ADDENDUM

PROJECT TITLE: Spruce Lake Screen Building Bypass Piping	ADD. NO: 1
TENDER NO: 2024-471001T	DATE: March 26 th , 2024
PAGE 1 of 2 (Including Confirmation Sheet)

SCREEN BUILDING **BY-PASS** PIPE CONNECTION DETAILS

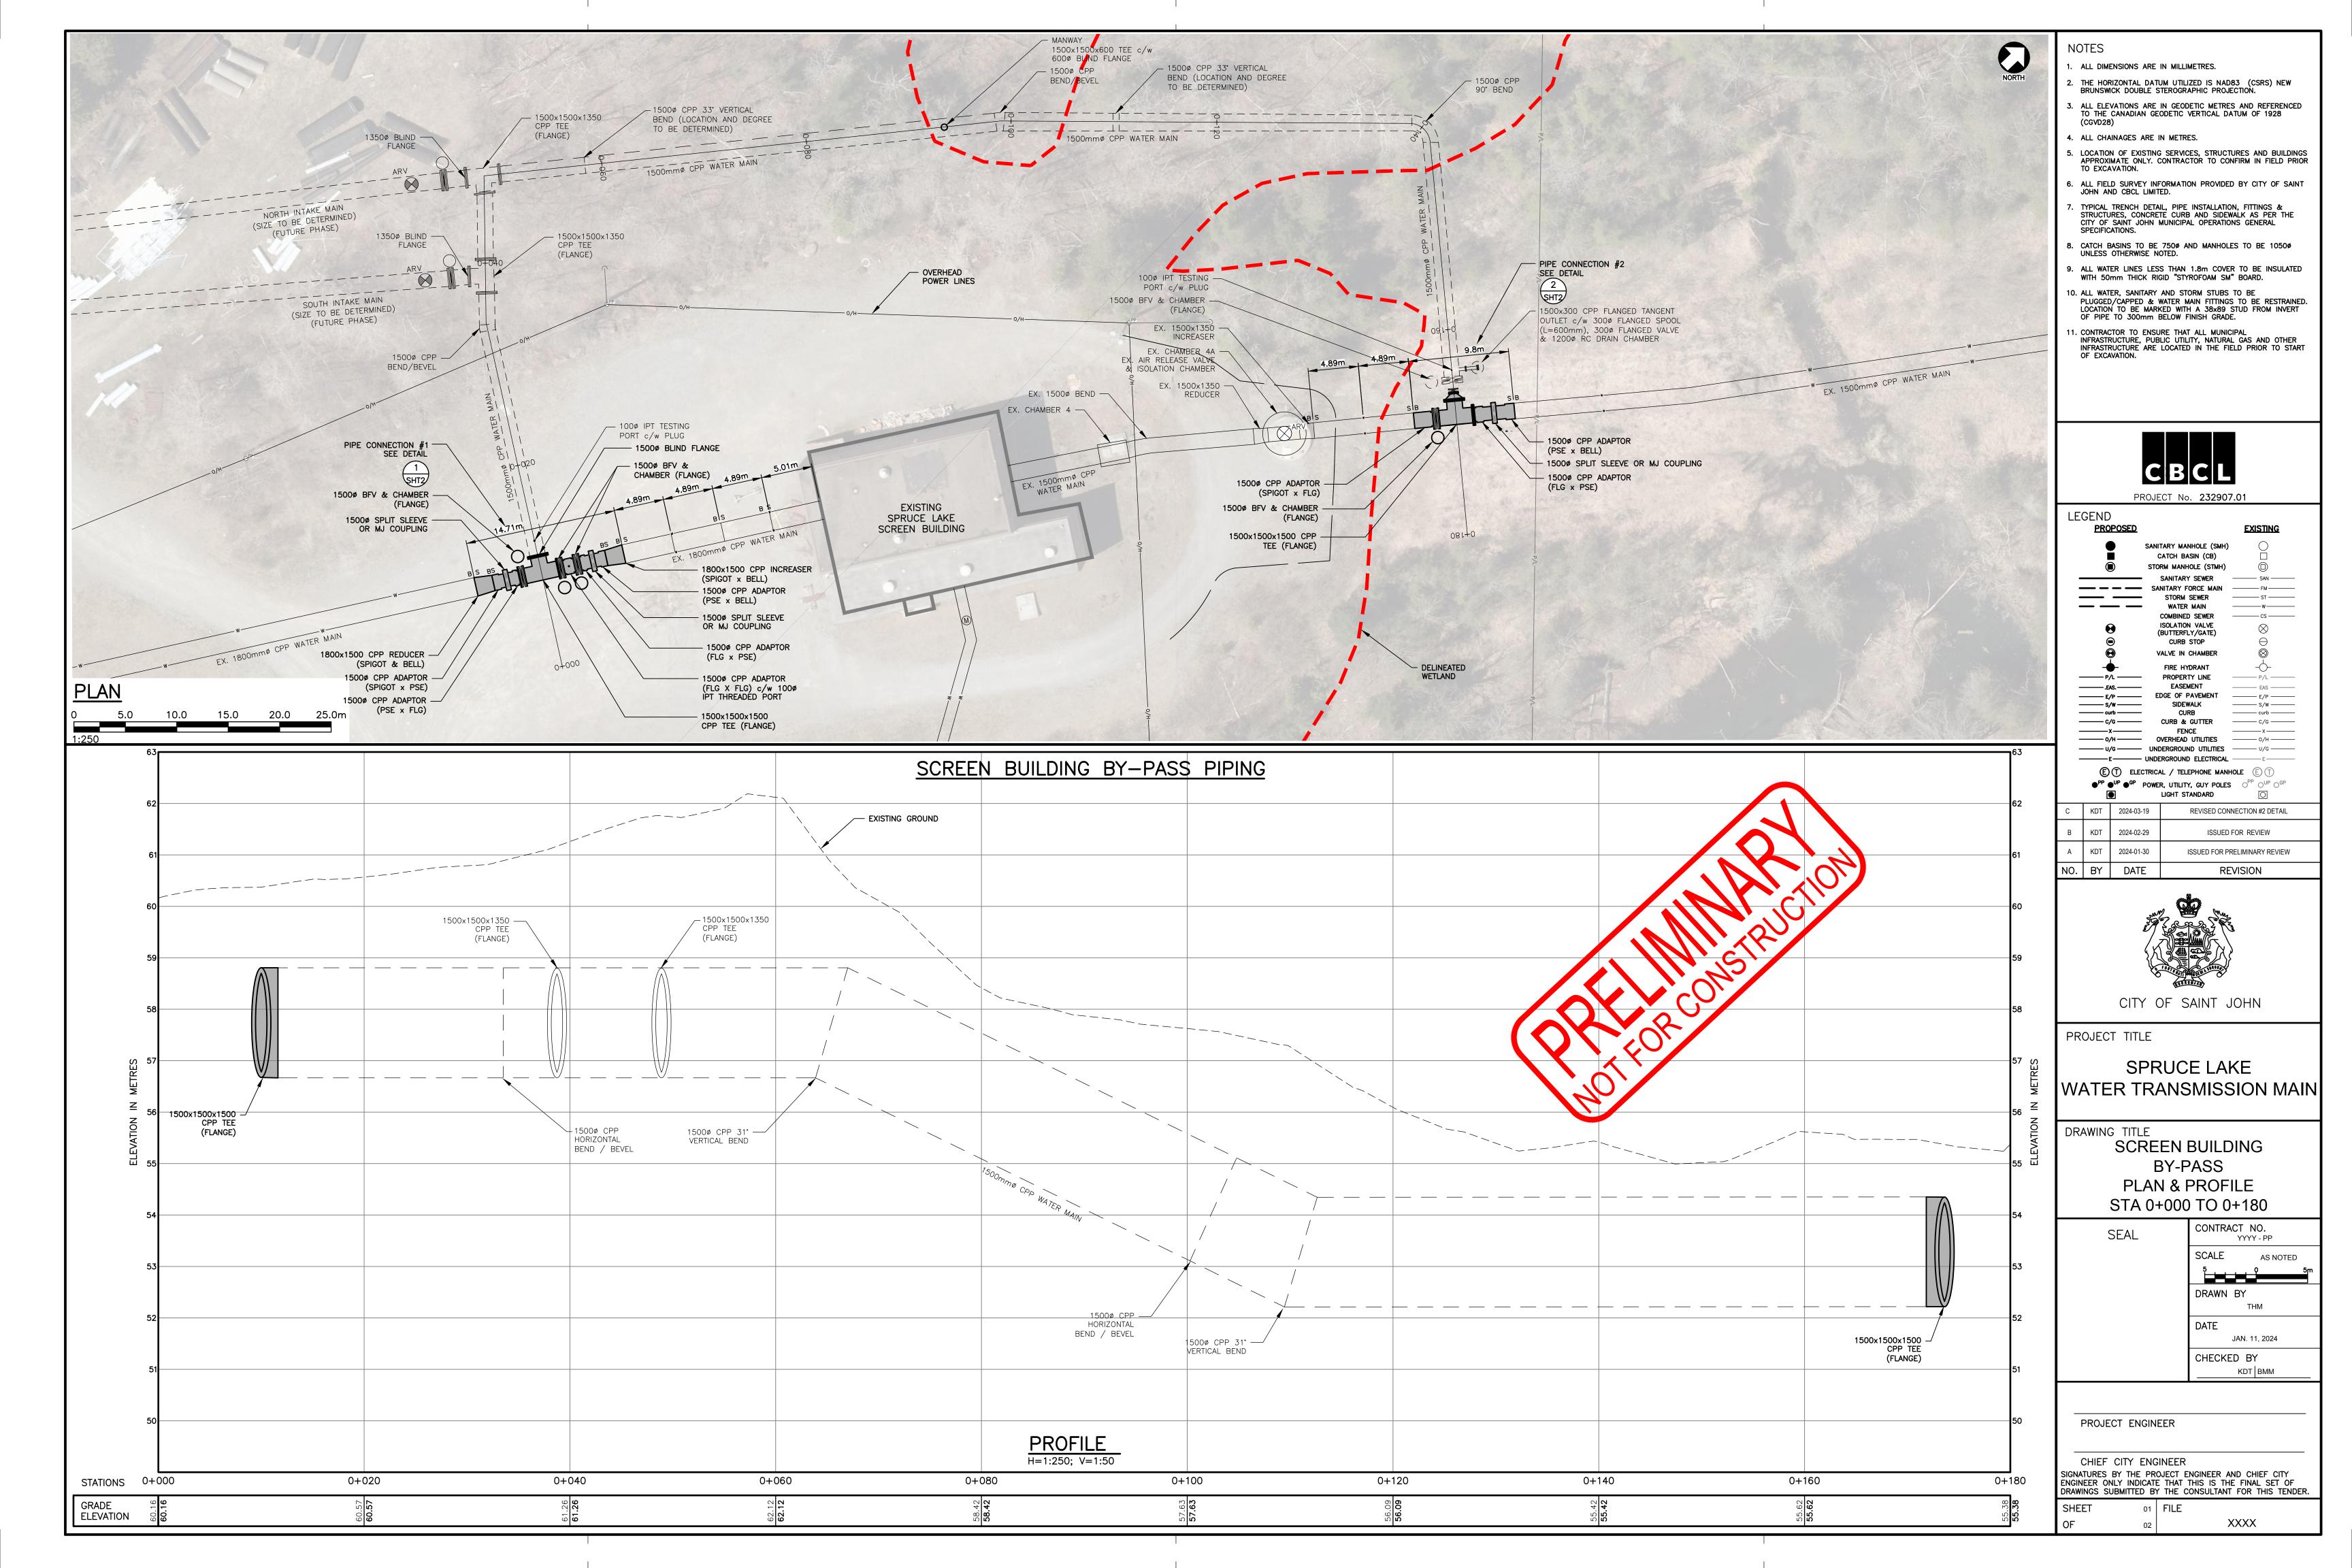
В	KDT	2024-03-19	REVISED CONNECTION #2 DETAIL
Α	KDT	2024-02-29	ISSUED FOR REVIEW
NO.	BY	DATE	REVISION
